ARTICLE 14. ONE AND TWO FAMILY DWELLING CODE

Rule 2.1. CABO One and Two Family Dwelling Code; Amendments

FIGURE R502.8
CUTTING, NOTCHING AND DRILLING

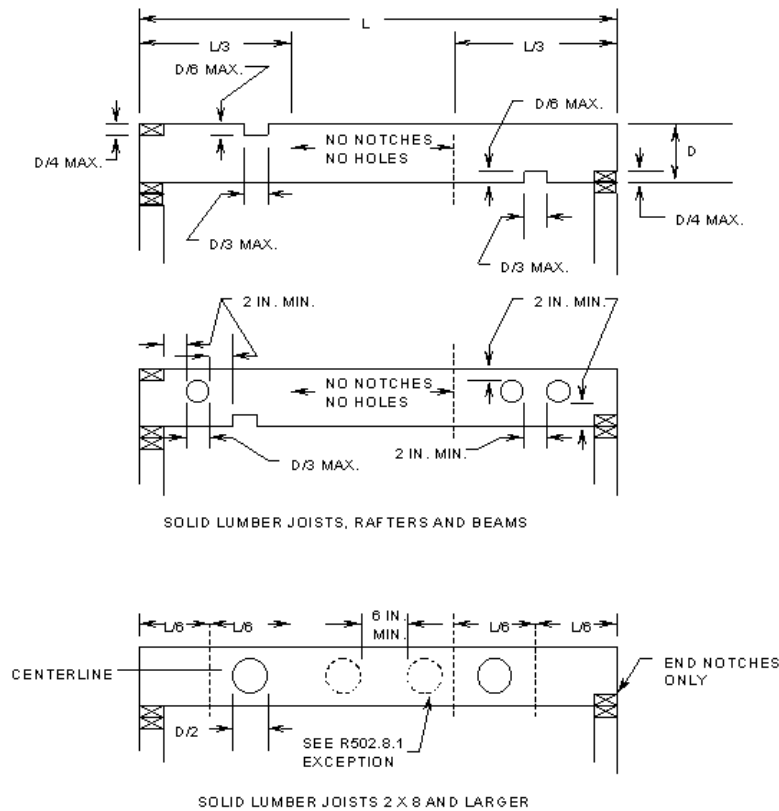
Sec. 88. Delete FIGURE R502.8 and substitute as follows: FIGURE R502.8:

Sec. 87. Add an exception to SECTION R502.8.1 to read as follows: EXCEPTION: In 2 × 8 and larger solid lumber joists, holes up to 50 percent of the actual joist depth may be drilled at the center of the joist depth in the second and fifth sixths of the joist span. When the joist spans 90 percent or less of its maximum allowed span per TABLE R502.3.1(1) or R502.3.1(2), such holes may also be located in the center third of the joist span. Such hole shall be no closer than 6 inches (152 mm) from any other hole. Except for end notches, no notches may be in the same half of the span as a hole allowed by this exception. *(Fire Prevention and Building Safety Commission; 675 IAC 14-4.3-87; filed Jun 13, 2005, 3:00 p.m.: 28 IR 3275, eff 90 days after filing with the Secretary of State)*

FIGURE R602.6(2)
NOTCHING AND BORED HOLE LIMITATIONS FOR INTERIOR NONBEARING WALLS

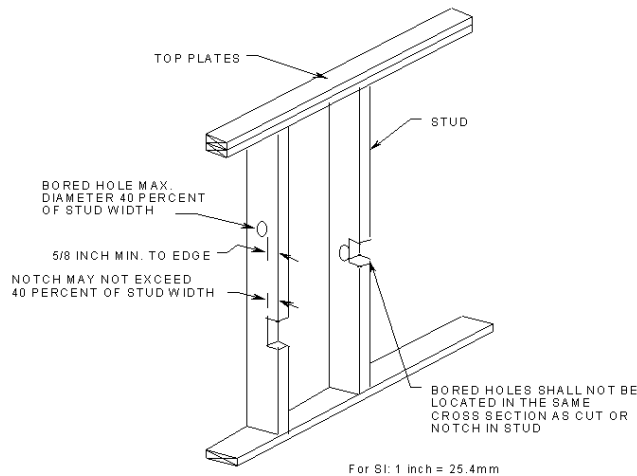
Sec. 95. Delete FIGURE R602.6(2) and insert FIGURE R602.6(2) to read as follows:

FIGURE R602.10.5(2)
GARAGE DOOR BRACED WALL PANEL FOR USE WITH CONTINUOUSLY SHEATHED WALLS

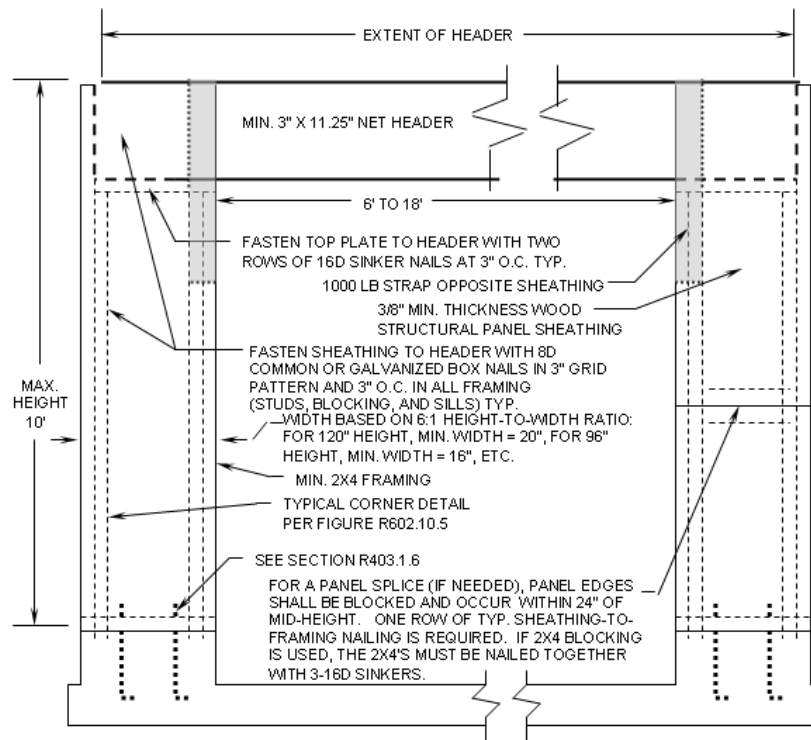
(4) Add FIGURE R602.10.5(2) to read as follows:

(3) Add an exception to read as follows: Exception: Vertical wall segments in the first of one or first of two story buildings next to garage openings shall be permitted to have 6:1 height-to-width ratio (with height being measured from top of header to sill plate) when constructed in accordance with the following provisions. Each panel shall have a length of not less than 16 inches (406 mm) and a height of not more than 10 feet (3,048 mm). Each panel shall be sheathed on one face with a single layer of 3/8 inch minimum thickness (9.5 mm) wood structural panel sheathing nailed with 8d common or galvanized box nails in accordance with Figure R602.10.5(2). The wood structural panel sheathing shall extend up over the solid sawn or glued-laminated header and shall be nailed in accordance with Figure R602.10.5(2). The header shall extend between the inside faces of the first full-length outer studs of each panel. The clear span of the header between the inner studs of each panel shall be not less than 6 feet (1,829 mm) and not more than 18 feet (5,486 mm) in length. A strap with an uplift capacity of not less than 1,000 pounds (454 kg) shall fasten the header to the side of the inner studs opposite the sheathing. Two anchor bolts shall be installed in accordance with Section R403.1.6, and plate washers shall be a minimum of 2 inches by 2 inches by 3/16 inch (51 mm by 51 mm by 4.8 mm) thick and shall be used on each bolt. This exception is only permitted in Seismic Design Categories A-C.

FIGURE R703.7.6(2)

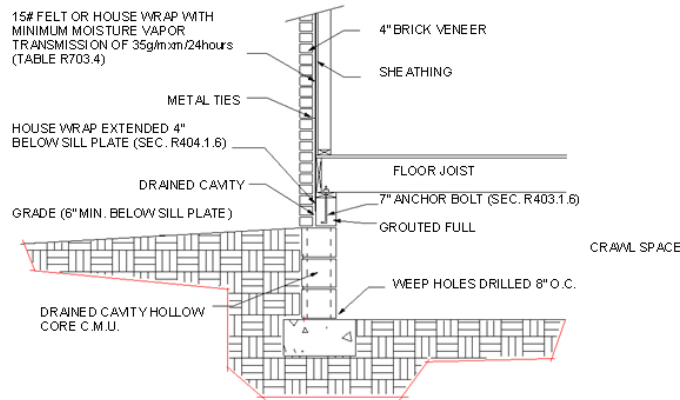
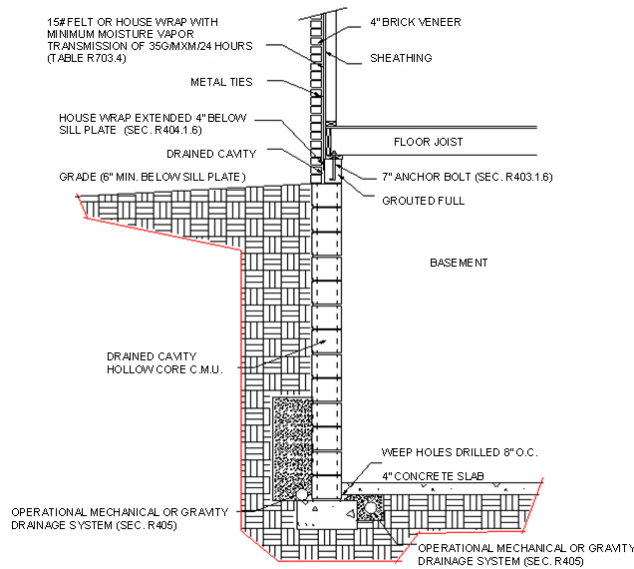
Sec. 121. Delete the title and text of SECTION R703.7.6 and substitute as follows: R703.7.6 Drained cavity. The ¾ inch (19 mm) air cavity shall be drained to the exterior of the structure at intervals of not more than 33 inches (838 mm) on center. Each drain shall be not less than 3/16 inch (4.8 mm) in diameter, located immediately above the flashing. For dwellings with crawl spaces, the air cavity may be drained as shown in FIGURE R703.7.6(1). For dwellings with basements, the air cavity may be drained as shown

in FIGURE R703.7.6(2).

FIGURE R1001.6
Chimney Termination

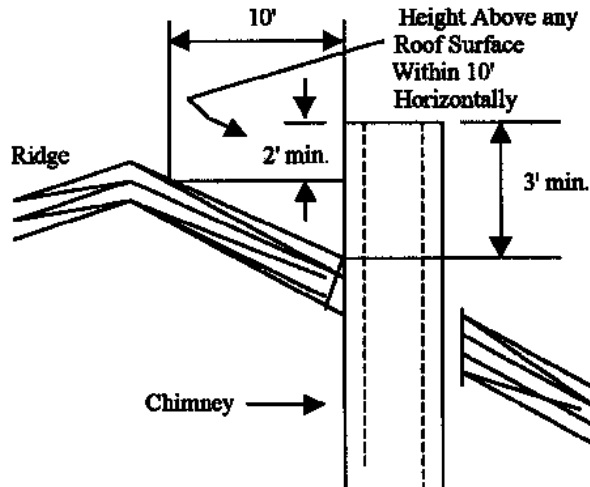
Sec. 135. Add FIGURE R1001.6 as follows:

FIGURE E3801.4.1

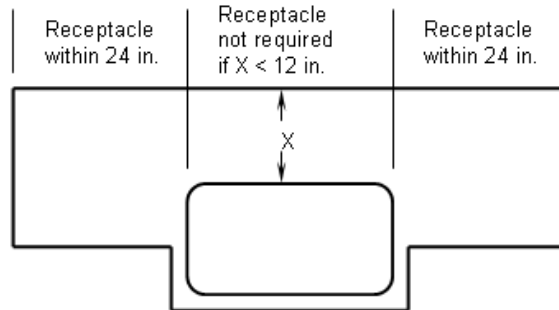
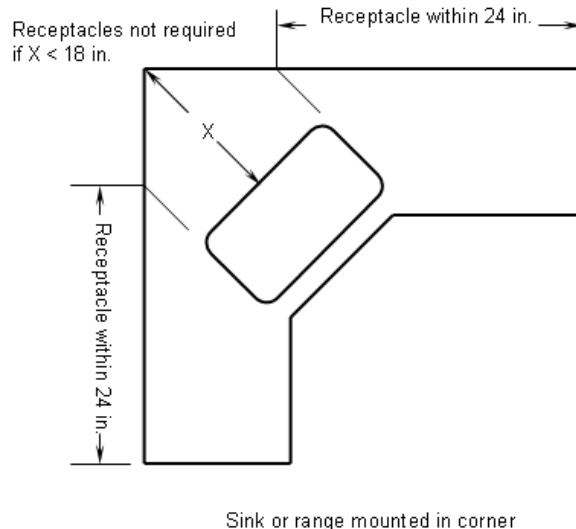
Sec. 229.5. (a) After SECTION E3801.4.1, add an exception to read as follows: Exception: Receptacle outlets shall not be required on a wall directly behind a range or sink in the installation described in FIGURE E3801.4.1.

(b) After SECTION E3801.4.1, add FIGURE E3801.4.1 as follows:
